LINCOLN CITY/LANCASTER COUNTY PLANNING STAFF REPORT

for February 2nd, 2005 PLANNING COMMISSION MEETING

P.A.S.: Windhoek 4th Addition, Special Permit #1386C, Community Unit Plan

PROPOSAL: An amendment to the Special Permit to add 17 lots to the Windhoek Community Unit Plan, including Build-Through lots, generally located at South 112th Street and Van Dorn Street.

**Special Permit #1386C
S. 112th & Van Dorn St.**

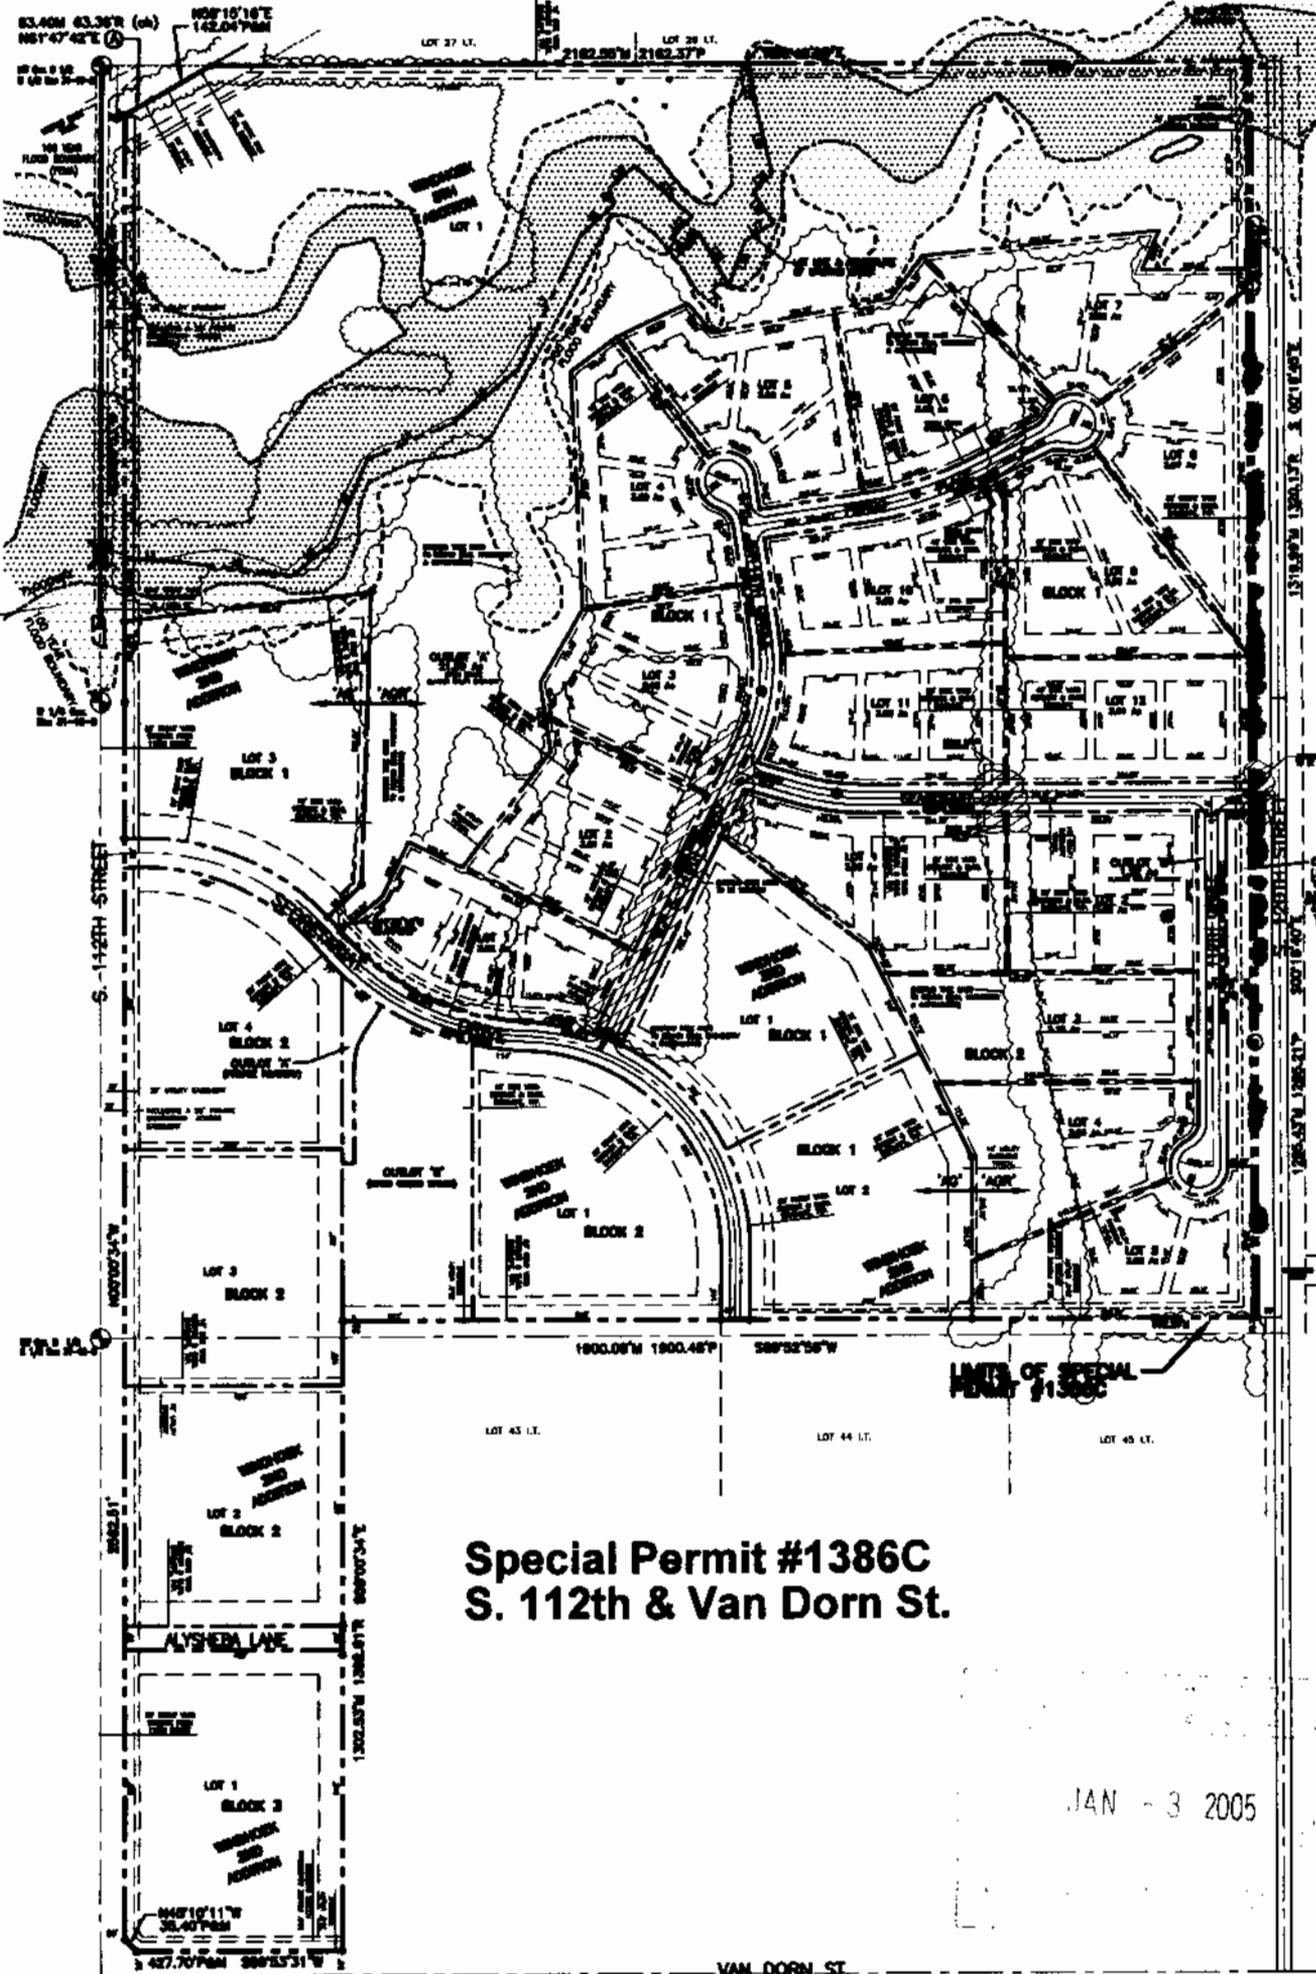
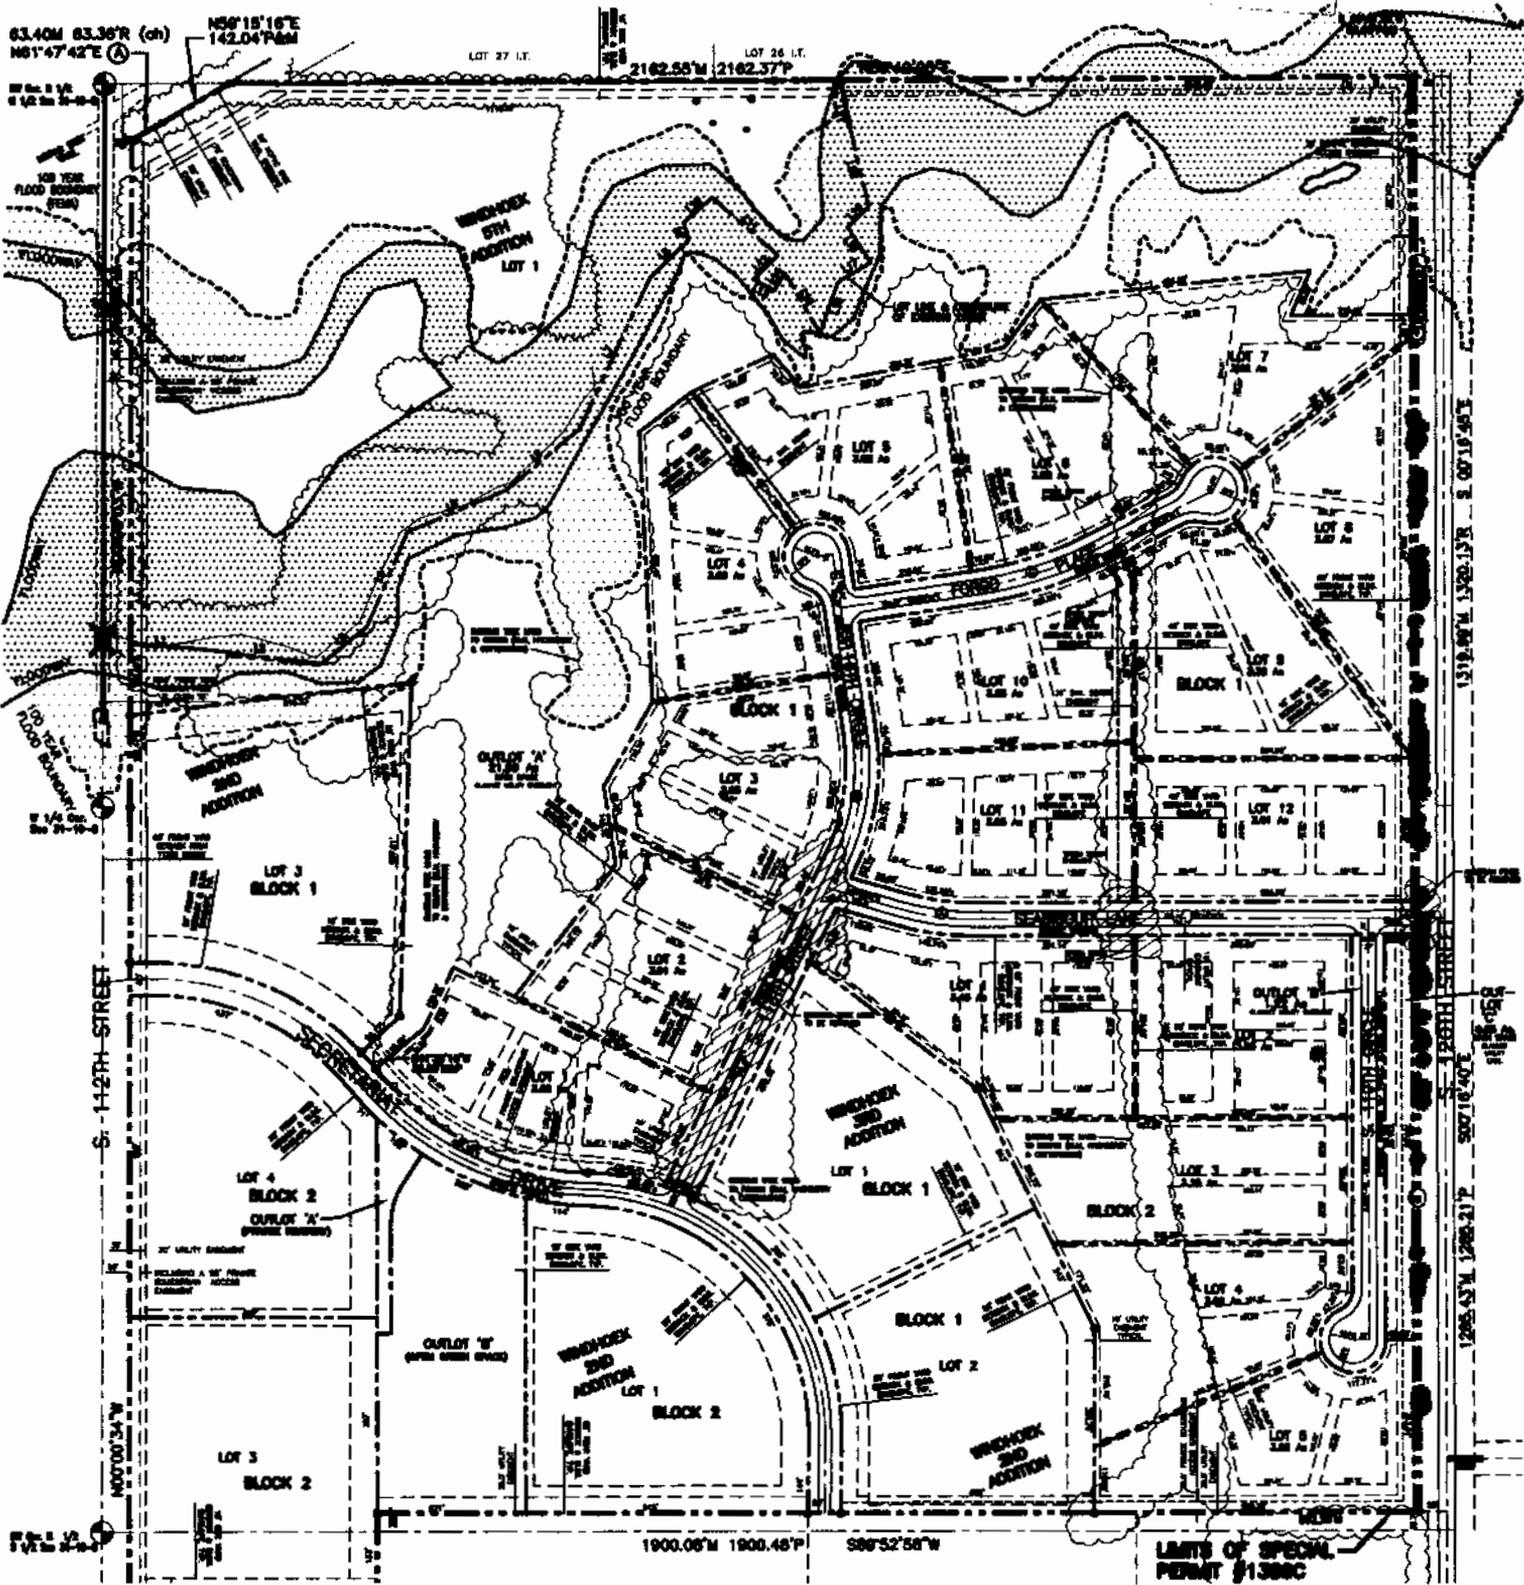
5.1.1.1 Make the revisions noted in the County Engineers memo of January 11, 2005 including;

- 1) Additional right-of-way dedication shall be shown to provide 60 feet of right-of-way on South 112th Street and South 120th Street.
- 2) The centerline grade of Forgo Place to Sta. 0+00 is one foot lower than the top of the culverts at Sta. 4+90. Water will be over the road before filling the pipe.
- 3) Culvert design information shall be submitted.
- 4) All culverts shall have either a flared-end section or concrete headwall on the inlet end.
- 5) Lots 3 through 8 should have minimum opening elevation shown that are based on the recent Stevens Creek Master Plan information.
- 6) Developer will be responsible for street signs, one "stop" sign and one speed limit sign.

5.1.10 Note on page 3 this is the "Transitional Plat".

5.1.11 Revise and note the street section on page 4 of 5 as the Rural Public Intermediate BTA Road Standard”.

5.1.13 Revise the location of S 119th Circle to the west about 250 feet to serve the south area. Remove Outlot ‘B’ and ‘C’ as part of that revision.

5.1.14 On Sheet 3 of 5, revise the back lots of Lot 3a,b,and c to reflect the realignment of S, 119th Circle (renumbered).

5.1.15 Provide a drainage easement along the creek bisecting Block 1 and Block 2.

5.1.16 Provide a pedestrian easement to Outlot A from the cul-de-sacs on Forgo Place and S. 116th Circle.

5.1.17 Note on page 2 of 5 that the revised floodplain/floodway is based on the Stevens Creek Watershed information and show the revised flood plain.

5.1.18 Revise Note #2 to reflect 26 lots.

5.1.19 Revise the Outlot lettering for five outlots.

(1.2) On the build thru plans, the easements shown along the east side of Lots 10 and 11 and between Lots 4 and 5 need to be 35' wide and labeled as sanitary and storm sewer easements.

(1.3) Minimum lowest floor elevations should be shown for Lots 1, 2, and 3 in Block 1 and Lots 2, 3, 4, and 5 in Block 3 to assure that standard depth sanitary sewer will be able to serve these lots by gravity from the streets.

(3.2) Culvert sizing and head water calculations need to be provided for Culverts A and C, and culvert sizing calculations need to be provided for Culvert B.

(3.3) Specific minimum opening elevations need to be listed for each lot adjacent to the 100yr flood boundary and any open drainage ways.

(4.1) The additional 10' of ROW dedication needs to be labeled on the plans.

(4.3) Wheatridge Drive near the southeast corner of the plat is at approximately the quarter mile line. This is a likely location for a future full access median break. The street system as shown does not allow for the future extension of Wheatridge to the west. A revision to the street layout should be considered to better facilitate this connection.
